# 1013 NE 45TH STREET

SDCI # 3037927-EG | MUP # 3037792-LU

RECOMMENDATION MEETING

03.28.2022

DEVELOPMENT DEPARTURE REQUESTS

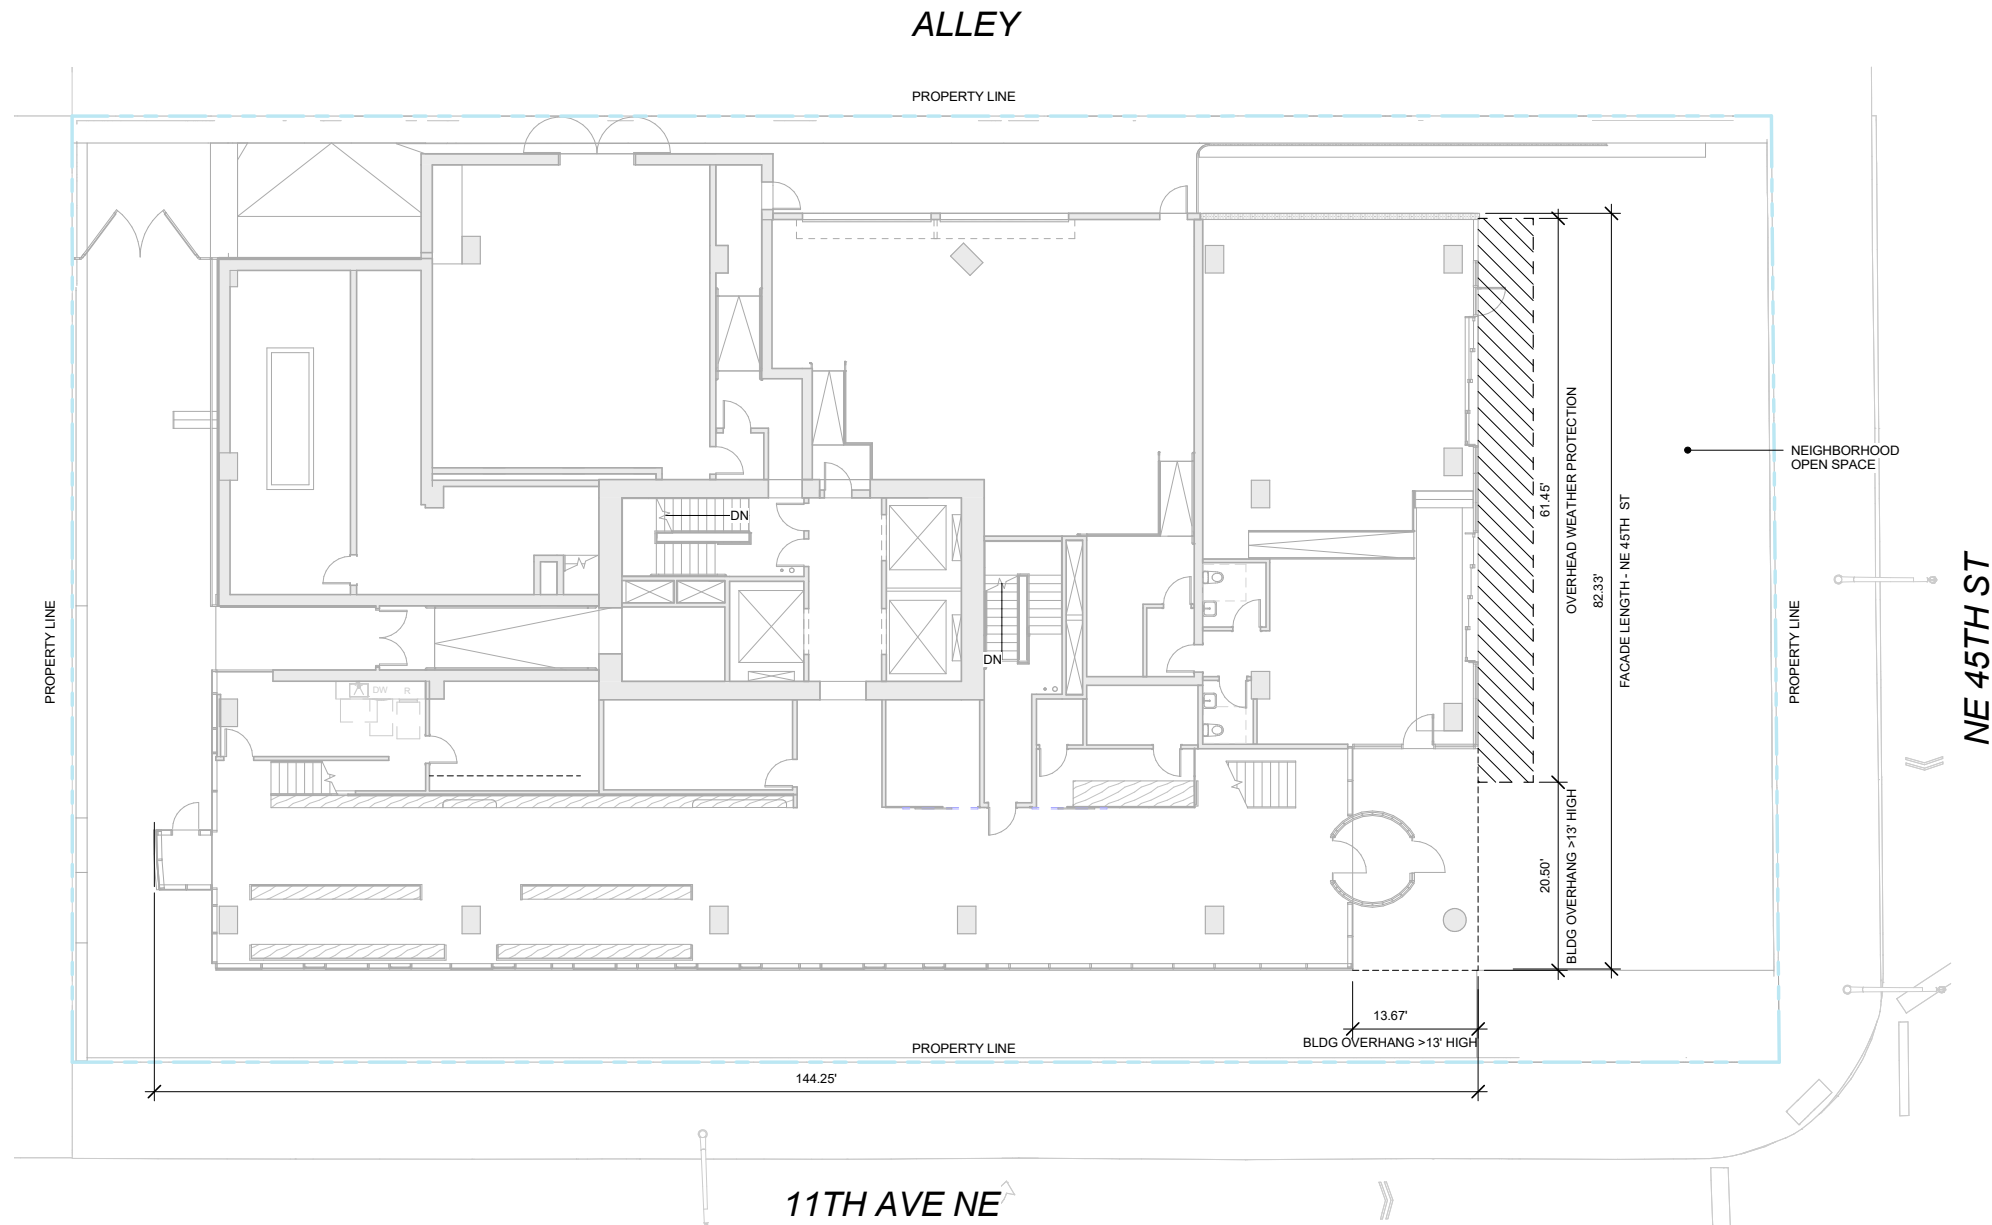
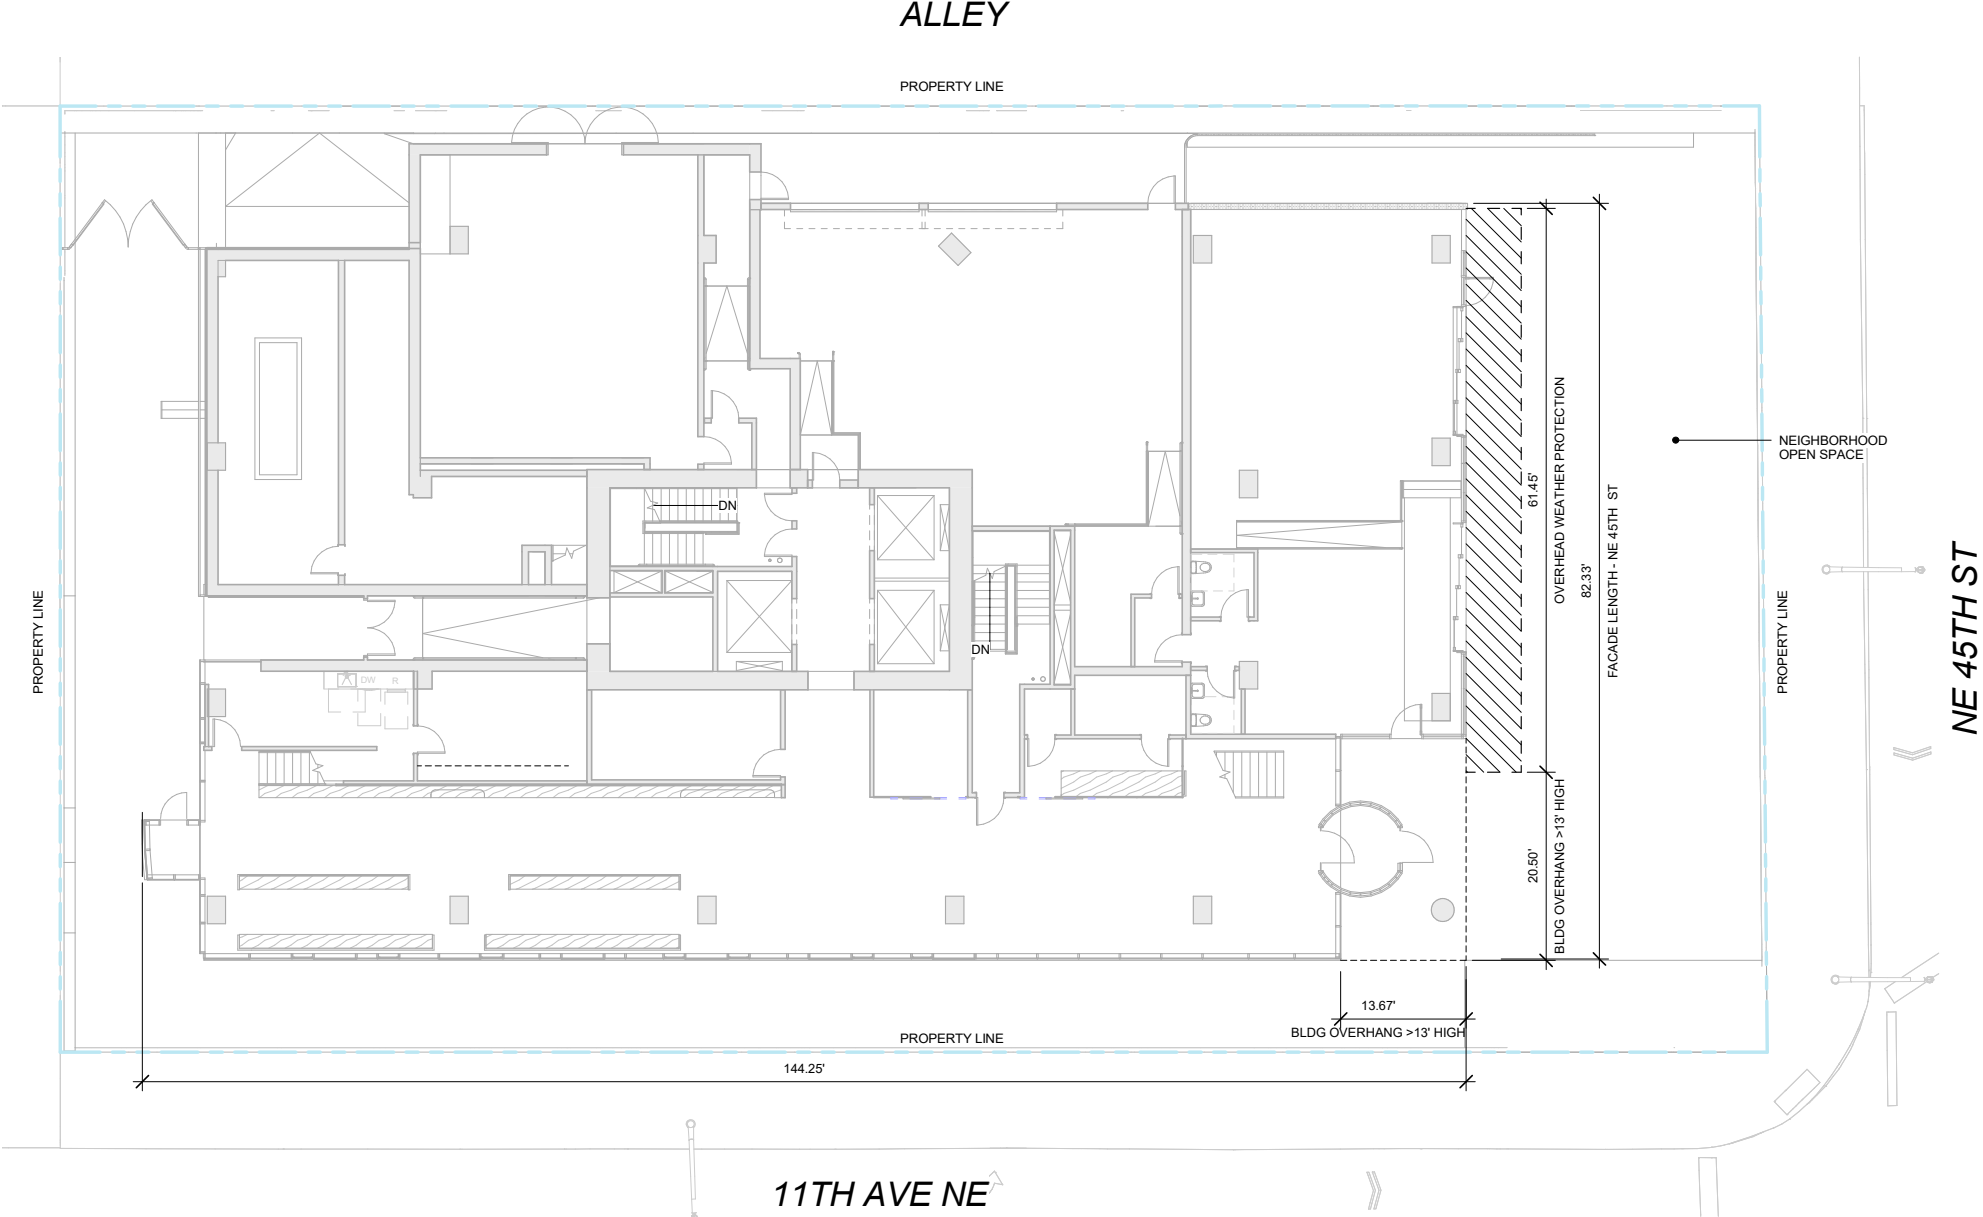
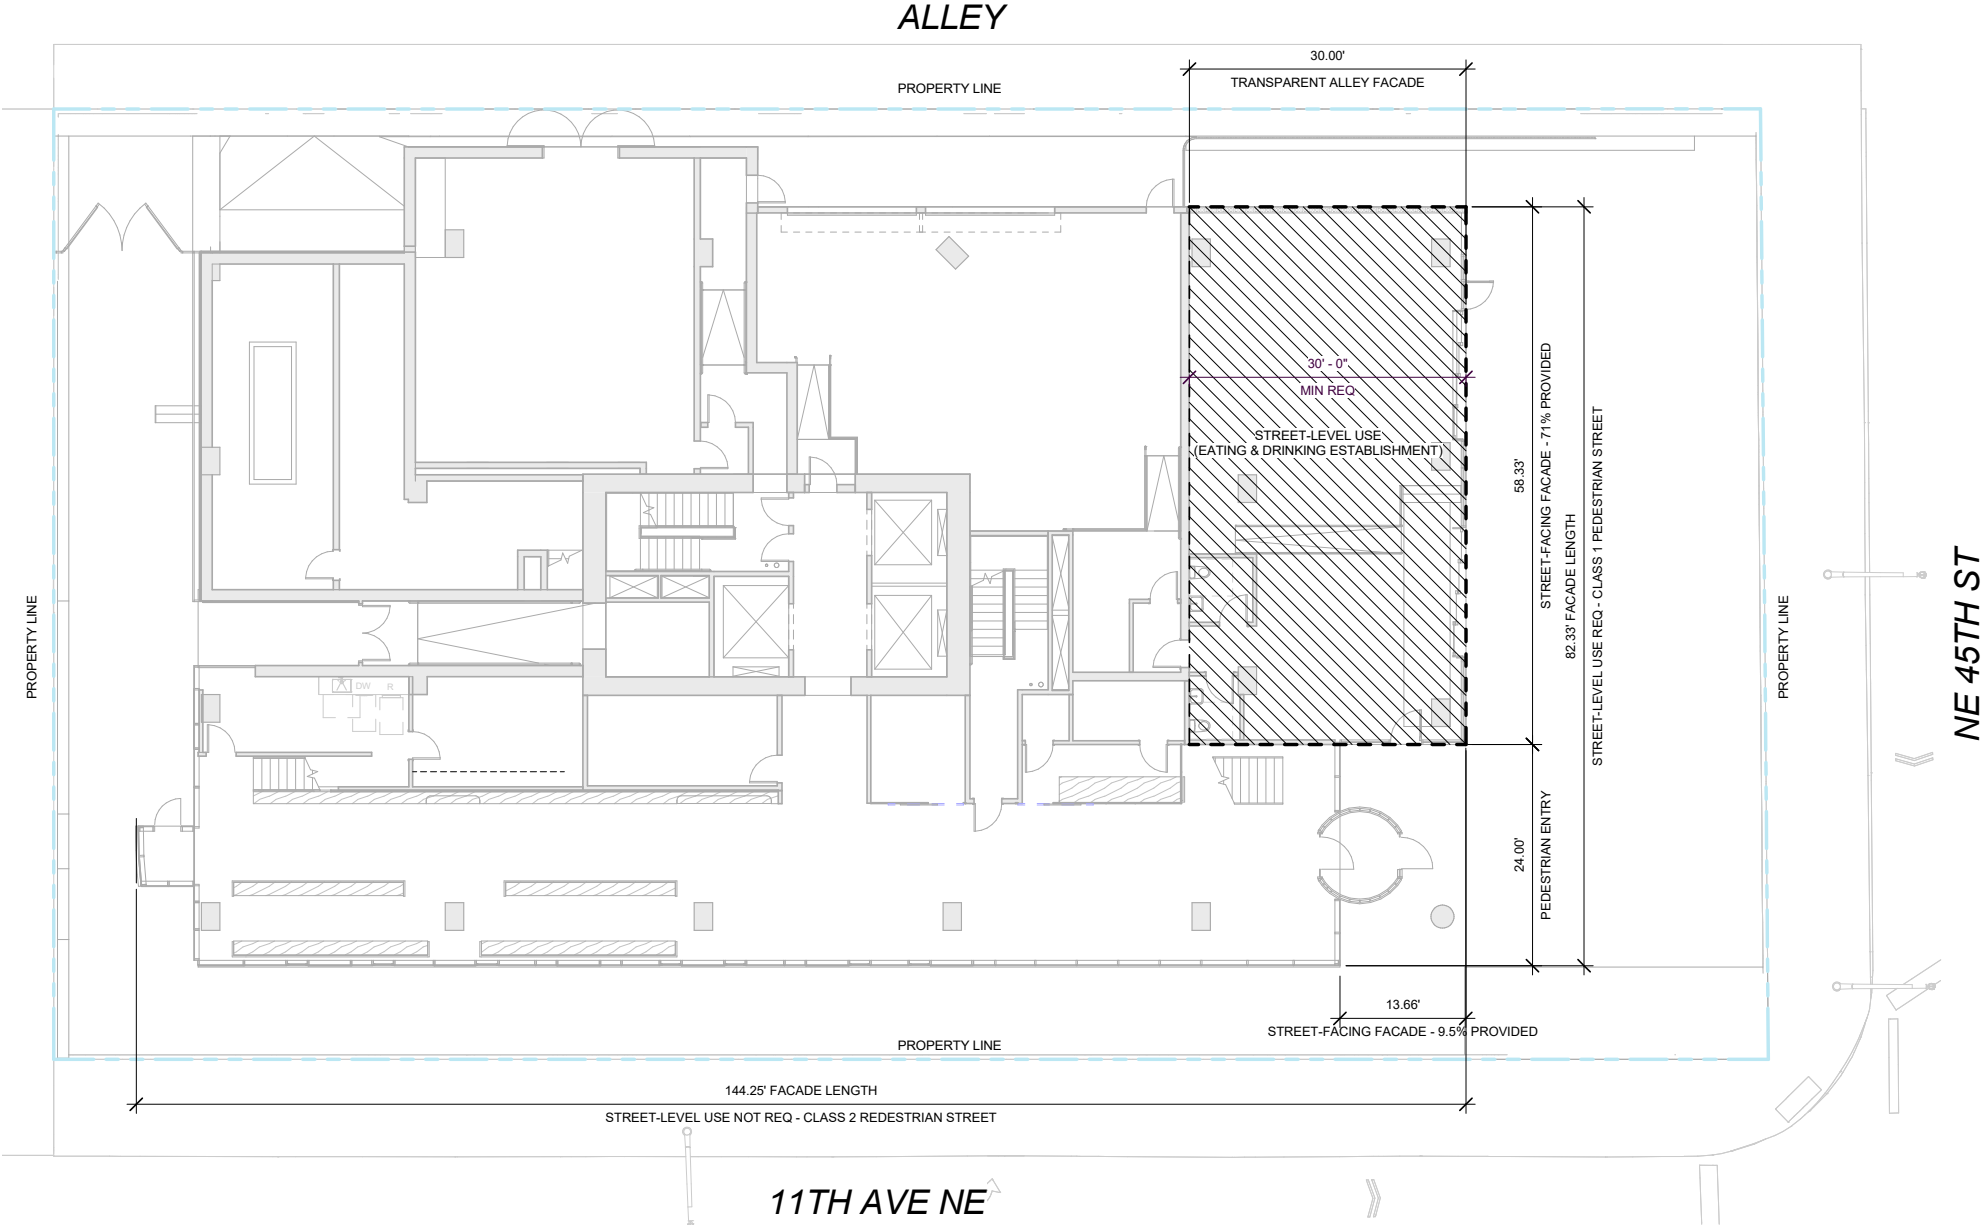
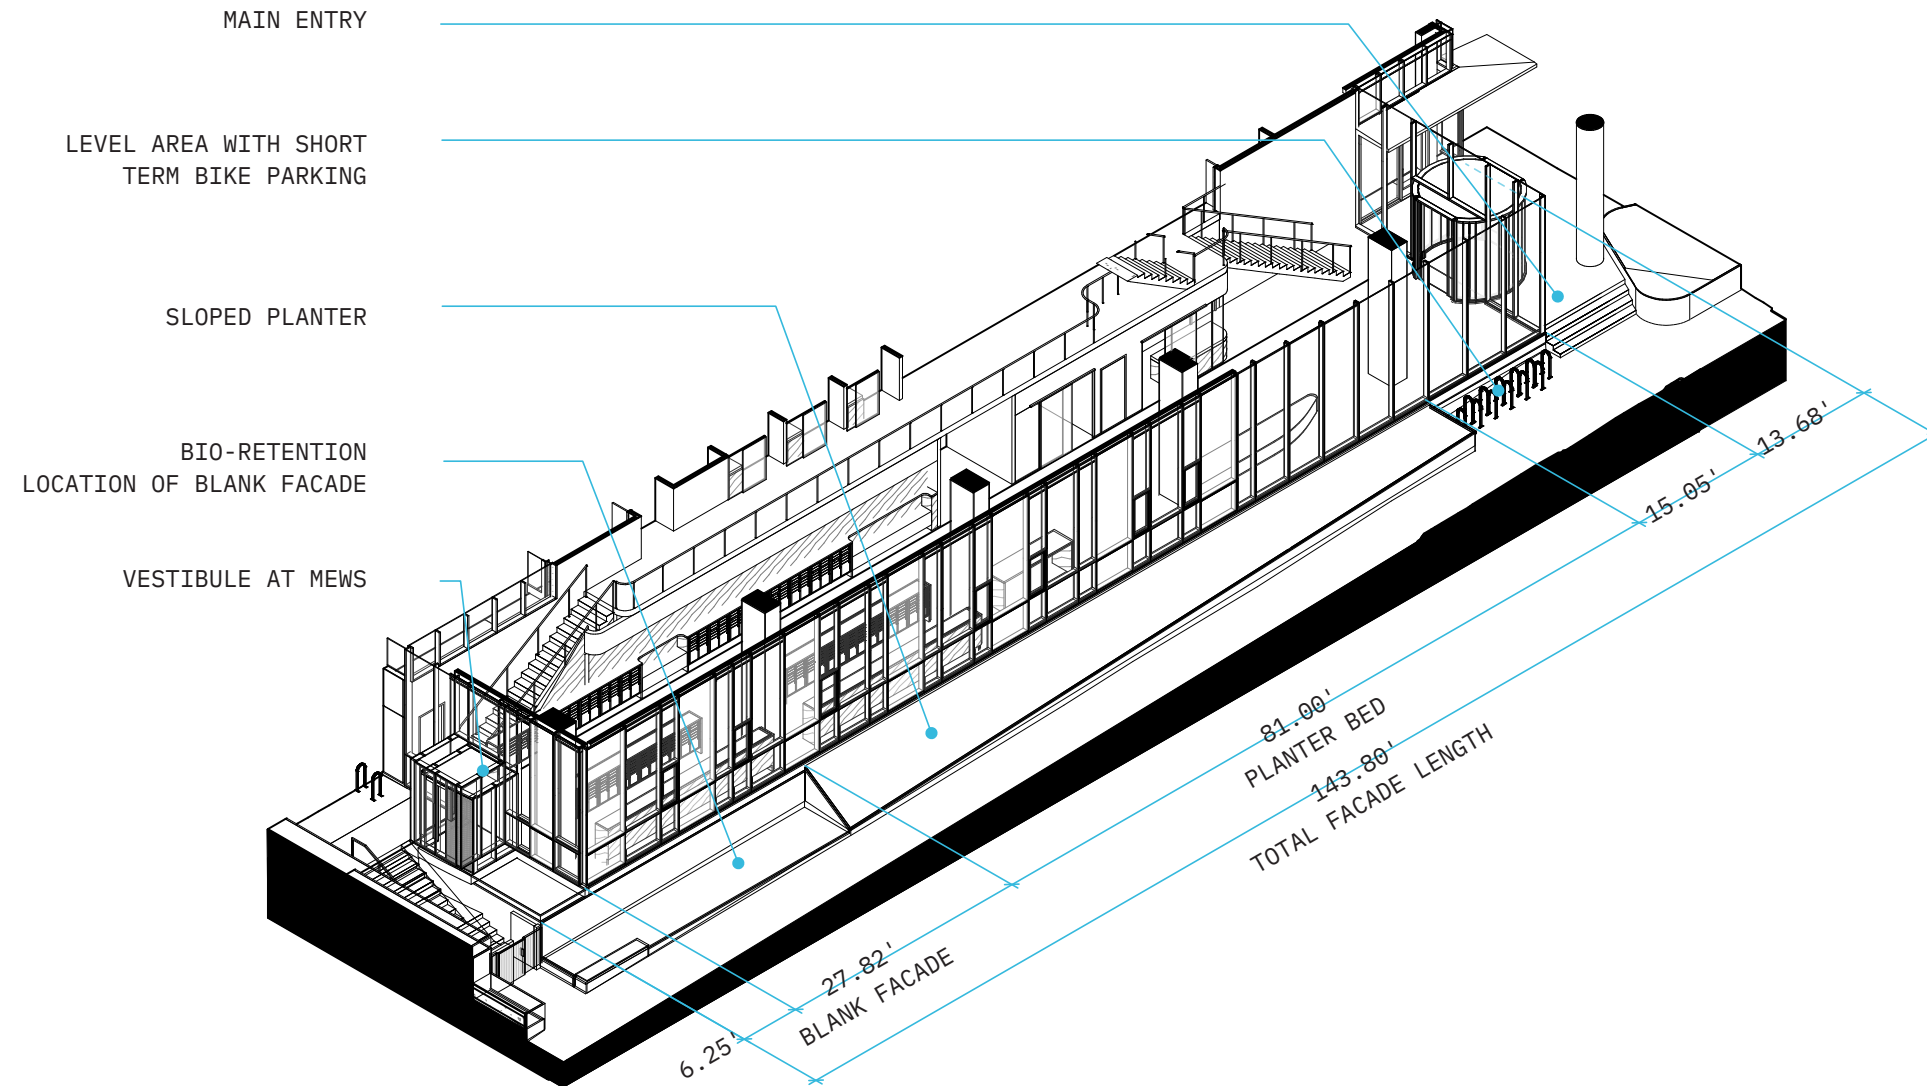
**FROM EDG REPORT #3037927-EG PG 5:**

|   | ZONING CODE                                      | REQUIREMENT  | REQUEST  | DEPARTURE JUSTIFICATION   | RELEVANT DESIGN GUIDELINES   |
|---|--|--|--|---|--|
| 2 | 23.48.640.F.1<br><br>OVERHEAD WEATHER PROTECTION | Overhead weather protection must be provided over the sidewalk or over a walking area within 10 feet immediately adjacent to the sidewalk. | The applicant requests to provide overhead weather protection greater than 10 feet from immediate adjacency to the sidewalk due to providing neighborhood open space between the sidewalk and the structure. | The preferred alternative proposes neighborhood open space along the entire length of NE 45th street. the open space along NE 45th street is 32'-0" +/- wide. (please see drawing 1/t1.101) the applicant proposes to extend overhead weather protection from the facade containing street level uses that are 32' +/- to the south of the property line. Thus placing the overhead weather protection greater than 10' from the row. | University DC2-2<br>Architectural<br>Concept & Facade<br>Composition<br>DC2-2.C<br>Cohesive Design |

Total street-facing facade with overhead weather protection:  
 $61.45'$

Total % of overhead weather protection:  
 $61.45' / 226.58' \times 100 = 27.1\%$  of total street-facing facade length

Required street-facing facade length:  
82.40 ft x 75% = **61.80 ft required**  
**58.33 ft provided**
